UNITED STATES PATENT AND TRADEMARK OFFICE

10/712,285

Office Action Summary	Application No. 10/712,285	Applicant(s) SINGHATAT, WAMIS	
	Examiner DIANNE DORNBUSCH	Art Unit 3773

DETAILED ACTION

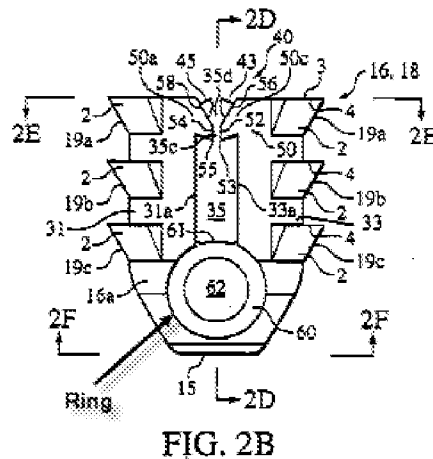
Claim 7: That the anchoring member comprises at least one annular ring (see Fig. below).
